**Review of Anglesea Groundwater Impact Assessment:
Upper Eastern View Formation**

By
Independent Technical Review Panel
February 2026

This ITRP report to SRW addresses a request for independent advice on whether the additional technical information provided by Alcoa in the updated Groundwater Impact Assessment (GIA)(EHS 2025) is sufficient for review and assessment of a groundwater licence amendment application for extraction from the Upper Eastern Valley View Formation (UEVF).

Figure 3- Predicted mine water body level (from GIA 2025, Fig.7-1)

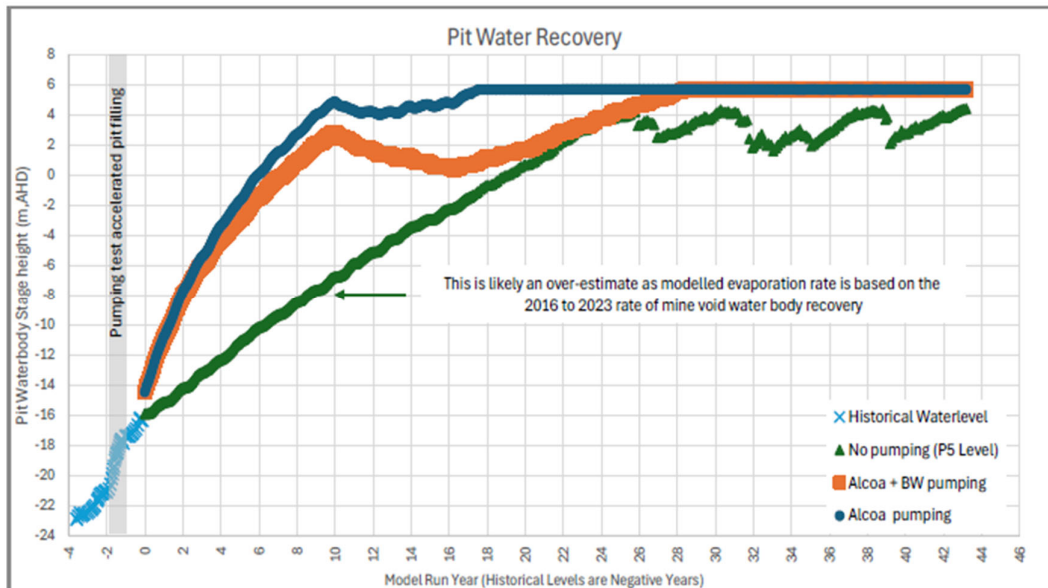
The modelling results show that the pit void water body acts as a long-term sink ('groundwater discharge feature') under all scenarios, although the GIA does not present a contour plan of groundwater levels to show the extent and magnitude of the sink 'cone of depression'. The long-term groundwater inflows are balanced by an ongoing evaporative loss of about 0.3 GL/a.

Figure 4. Composite plot of measurements and model predictions demonstrating that climatic drivers (not pumping effects) dominate the ASA system (from GHD 2024a, Fig. 6-14)

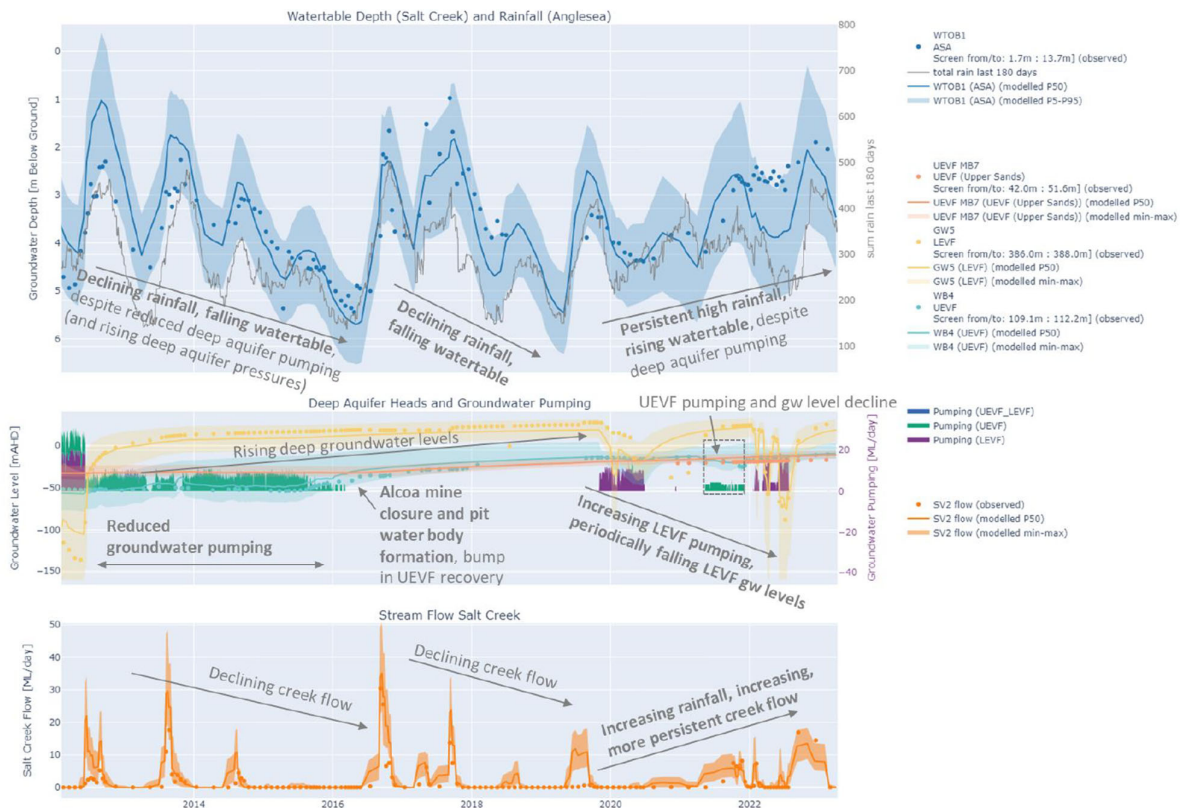
The ITRP was impressed by the insights available from analysis of the composite plots presented in the model calibration report (GHD 2024a, Figures 6-14, 6-15; presented below as Figure 4). They provide an effective mini-hindcast within the history-match period when there were distinct campaigns of groundwater pumping (or no pumping) from the Barwon Water and/or Alcoa borefields, and demonstrate clearly that climatic drivers dominate ASA system. This is not surprising in the Anglesea Syncline area, north of the mine area, where the ASA is a predominantly losing system. Further investigation is recommended by the ITRP to benchmark the proxy hydraulic indicators (e.g. drawdown) to ecosystem impacts such as acidity mobilisation, oxygen depletion in waterways and/or fish-kill information for 2016-2020, to provide insights to confirm

whether the model and the proxy indicators are indeed suitable for such ‘unpacking’ of the key hydrological drivers.

Figure 5 - Stable water table levels in the ASA compared with drawdown in the deeper UEVF and LEVF aquifers from 2009 to 2022. The effects of pumping are evident in the deeper aquifers at various times, including the 6 month pump test (from GHD 2024a, also Appendix E to GIA (EHS 2025)).

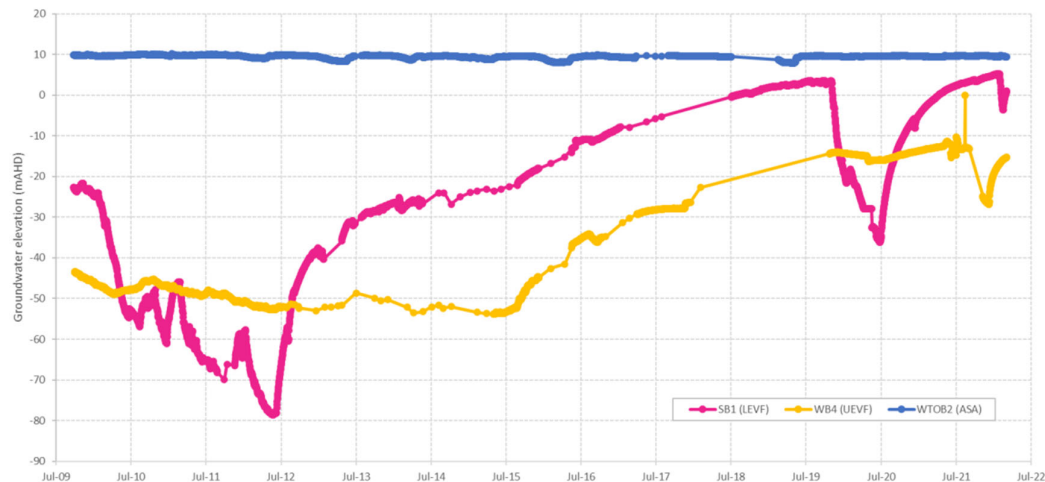
However, the ITRP review has found that there could be a **risk of moderate groundwater drawdown despite the relatively small volume** of the proponent's proposed groundwater take, which **may be a material acid generation risk** as discussed below.

Groundwater model scenarios project a small to moderate drawdown (0.1 to 2 metres) of the water table in some ASA areas during 10 years of Alcoa's proposed pumping from the basal sands of the UEVF. The GIA has tended to focus on the predictions of small drawdown (<0.1 m), and has not highlighted that there is evidence that predicted groundwater levels due to Alcoa-only pumping may be deeper in some areas (e.g. <2 m) compared to historical variations in response to rainfall and other cumulative effects including previous pumping. The ITRP consider that such small to moderate drawdown is not a major concern in terms of the ecological basis for the guidelines for groundwater dependent ecosystems (DELWP 2015a), but is a material concern in terms of potential acid generation, as discussed further below.

Figure 6 - Model scenarios projecting water table drawdown in the ASA due to proposed groundwater pumping. (from GIA 2025, Figure 7-5).

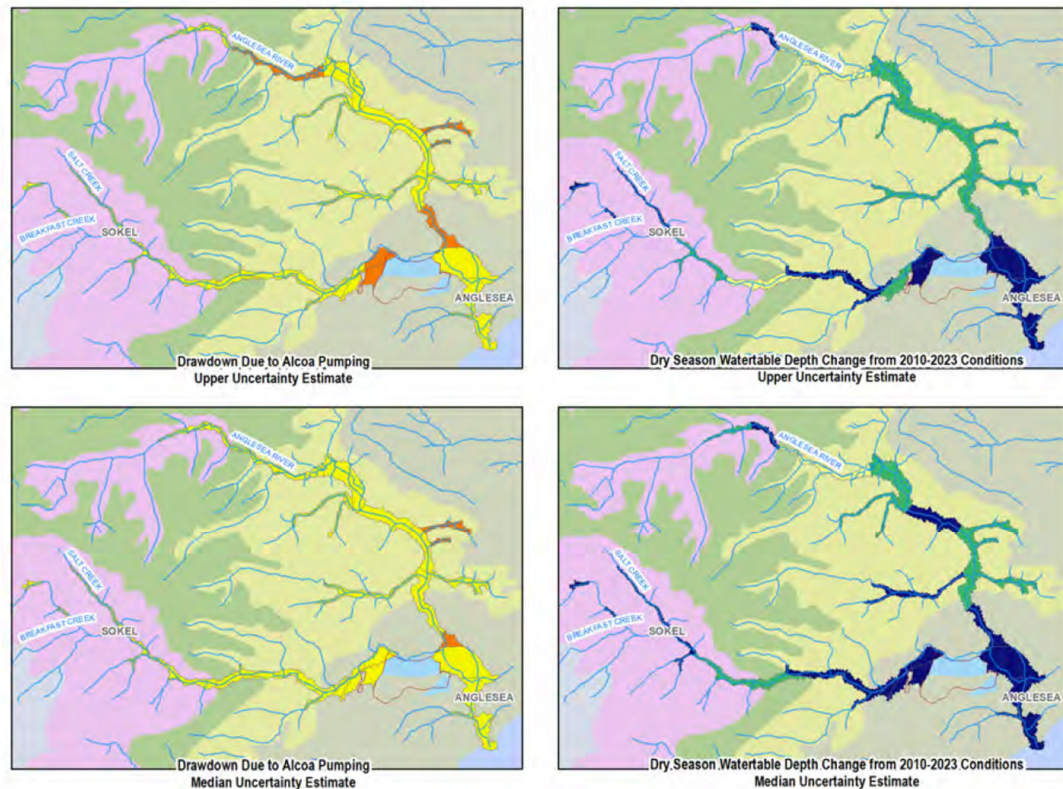
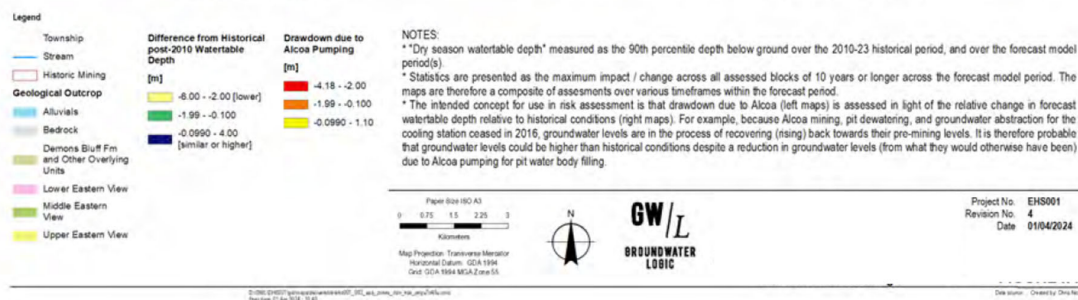
The modelling shows that hydrological and acid generating processes in the ASA are driven predominantly by climatic effects and that ASA drawdown due to UEVF pumping at 1.5 GL/a is small. For example, Figure 6 below shows <0.1m incremental or 'unpacked' effect due to Alcoa pumping only for medium climate change (yellow areas), but some areas up to 2m drawdown (orange) in the mid-Anglesea catchment. Such additional moderate drawdown would drive additional oxidation of sulfidic sediments and acid generation processes outside the mine area.

The **ITRP review is not confident that the modelled impact of proposed pumping on drawdown in the ASA would not contribute to acid generation** (when compared to natural water table fluctuation). For example, the GIA Figure 7-5 caption does not clearly highlight the green areas (right frame) where it is probable that groundwater levels would be 0.1 to 2 m lower than historical conditions (i.e. high risk of acid generation). The left frame shows (orange) areas of Alcoa-only drawdown of 0.1 to 2 m in the mid-Anglesea swamps that align with the predictions of lower than historical water table levels (i.e. also high risk). These mid-swamp areas also host the persistent pools AGP2 and ASP7, as discussed later.

These areas are not reported by GIA 2025 as high risk because the risk assessment criteria for acid generating events (GIA 2025, section 8.1.2) uses drawdown and its seasonal variability at two specific ASA bores (WTOB1 and WTOB2) rather than the spatial drawdown plots shown above (along with the zero-flow days criterion). The P50 Alcoa-only drawdowns at these two bores do not exceed the 0.1 m minor consequence criterion for the median or high climate change scenarios (e.g. GIA Figs 7-2, 7-8). However, the predicted water table depth seasonal range due to Alcoa-only pumping does extend into the moderate consequence range of 0.1 to 1 m (e.g. GIA Fig 7-12, 7-14), indicating water tables deeper than historical observations, which would very likely invoke a high risk of acid generation events.

In summary, while the risk assessment uses reasonable proxy hydraulic indicators (drawdown) at WTOB1 And WTOB2 (along with the zero-flow days criteria), it does not consider spatially mapped drawdown metrics that are readily available for other sensitive swamp areas (such as persistent pond locations in the mid-Anglesea catchment). The ITRP reviewers subsequently requested additional data and analysis which was provided in December 2025 (EHS 2025b), showing more granular detail on drawdown than the aggregated/averaged plots presented in the GIA (2025), as discussed later.
